Title of Change:	D2PAK Case Outline Standardization from 418B-04 to 418AJ for all effected devices manufactured in On Semiconductor Seremban, On Semiconductor Vietnam and TFME facility.
Effective date:	14 July 2019
Contact information:	Contact your local ON Semiconductor Sales Office or <Norsahida.sahman@onsemi.com>
Type of notification:	This Product Bulletin is for notification purposes only. ON Semiconductor will proceed with implementation of this change upon publication of this Product Bulletin.
Change Category:	<input type="checkbox"/> Wafer Fab <input type="checkbox"/> Assembly Change <input type="checkbox"/> Test Change <input checked="" type="checkbox"/> Other <u>Case Outline</u>

ON Semiconductor is migrating the D2PAK discrete package case outline from version 418B-04 to version 418AJ. The change impacts the Rectifier, BJT and MOSFET product lines. This transition allows ON Semiconductor to standardize its significantly increased portfolio on a single case outline.

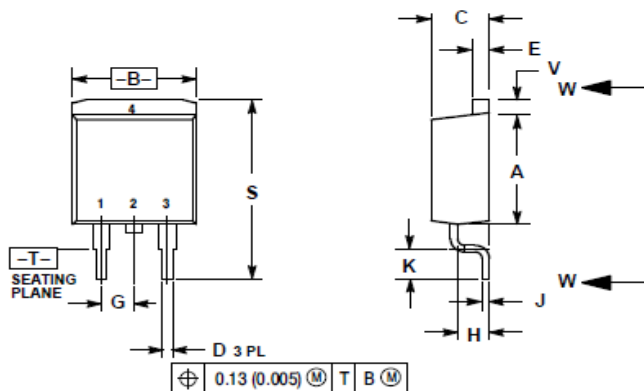
This notification does not represent a change to existing materials, tools or processes used to manufacture the affected devices. The new case outline, 418AJ, is consistent with JEDEC dimensional guidelines for the D2PAK.
